2006 - 2009 Cadillac XLR XLR-V: Service Bulletin: #16-NA-130: No Reverse, No Second After Upper Valve Body Replacement

#16-NA-130: No Reverse, No Second After Upper Valve Body Replacement - (Apr 27, 2016)

Subject: No Reverse, No Second After Upper Valve Body Replacement

Location of the four post shown above.

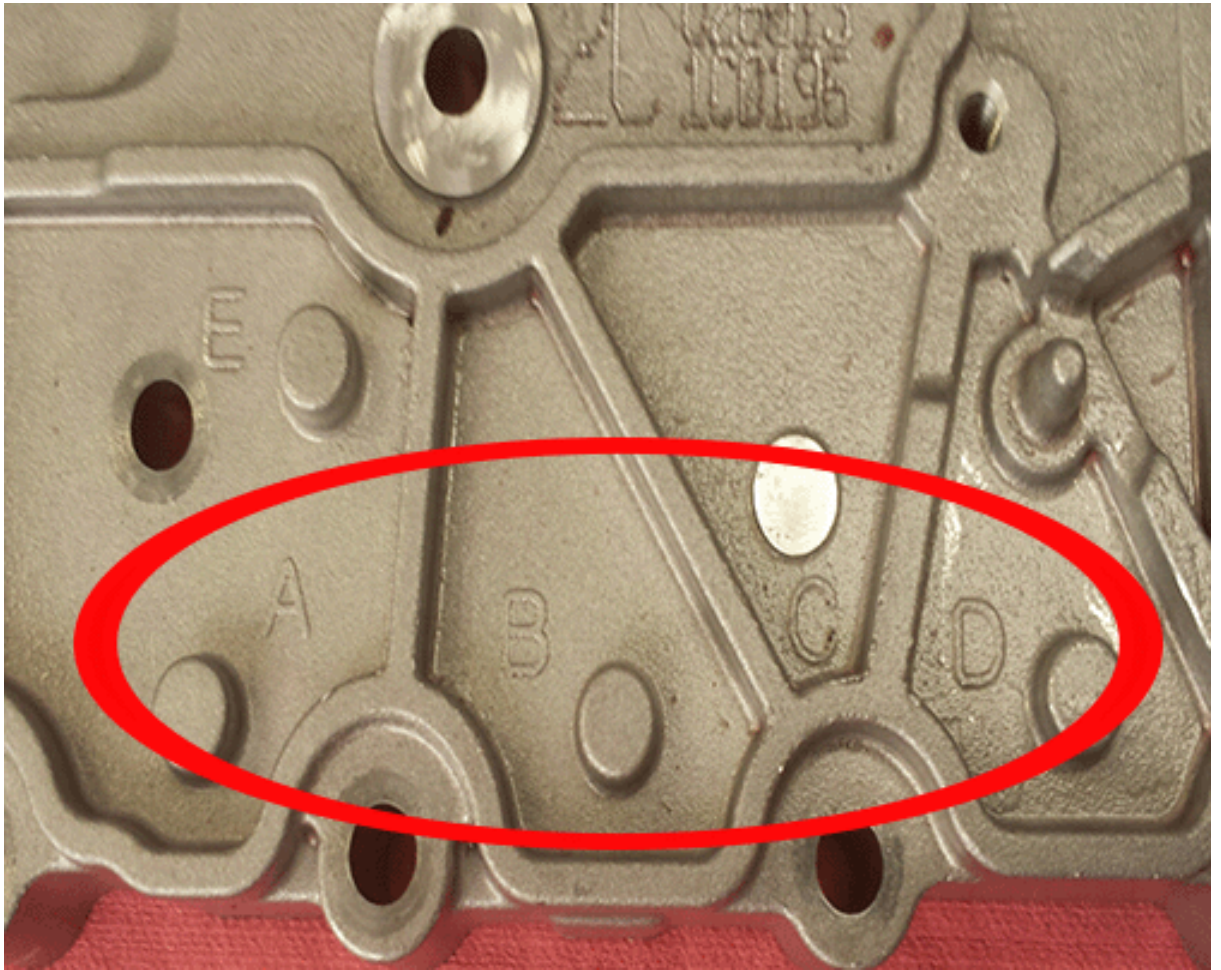
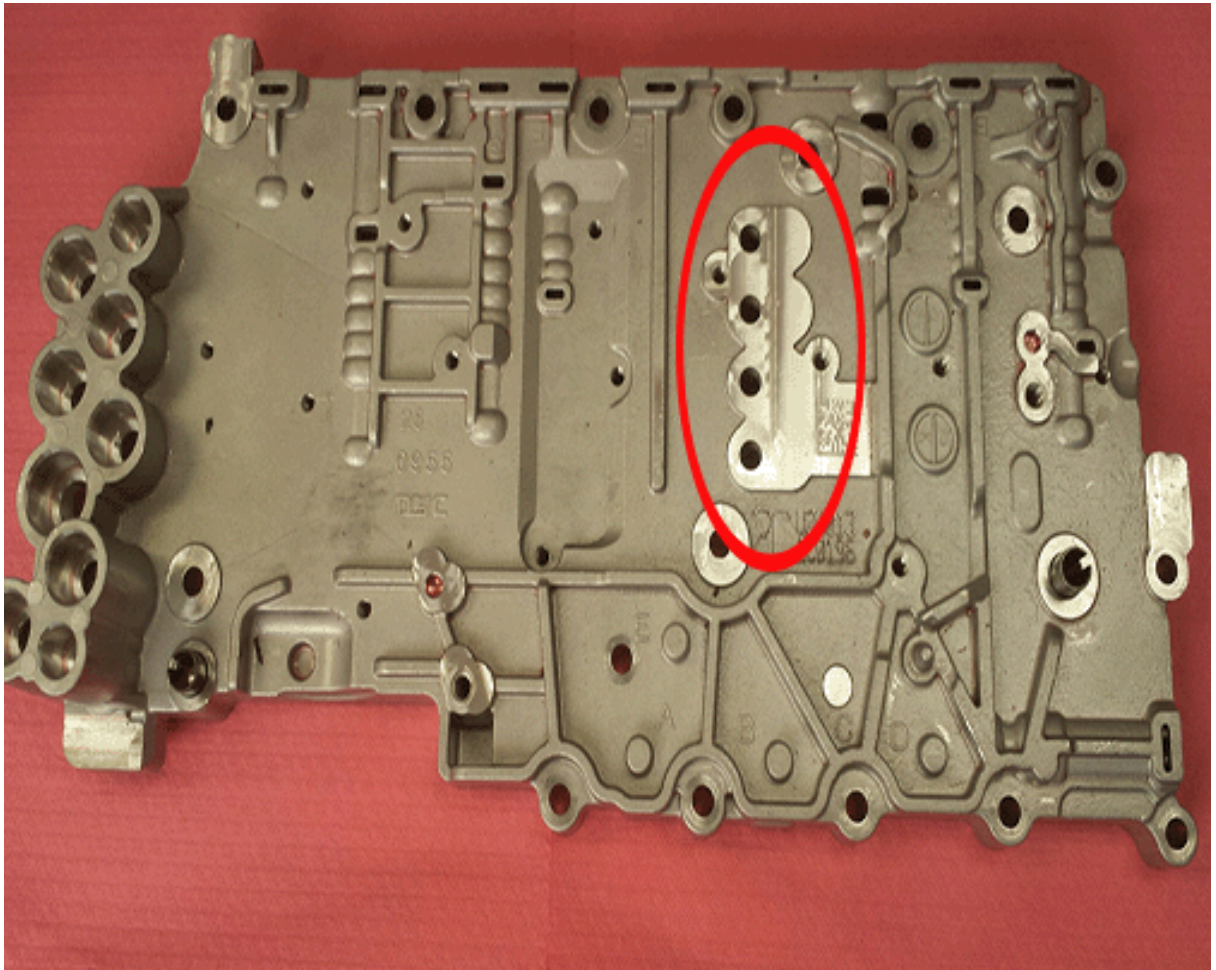
Upper valve bodies are unique by transmission RPO. Each upper valve body has four posts labeled A, B, C and D on the top side of the upper valve body. Inspect the upper valve body as shown below to determine the correct RPO usage.

The post corresponding to the correct RPO will be milled off. In this case the “C” post is milled indicating that this is an MYC upper valve body. A milled “A” post indicates MYA, a milled “B” indicates MYB, a milled “C” indicates MYC and a milled “D” indicates MYD.

The oil passage holes that feed the center support and Low and Reverse Clutch and 2-6 Clutch contained within the center support vary location by transmission and corresponding upper valve body. The ISS and OSS mounting locations also vary by transmission. The incorrect valve body does not properly locate the oil feed holes and speed sensors.
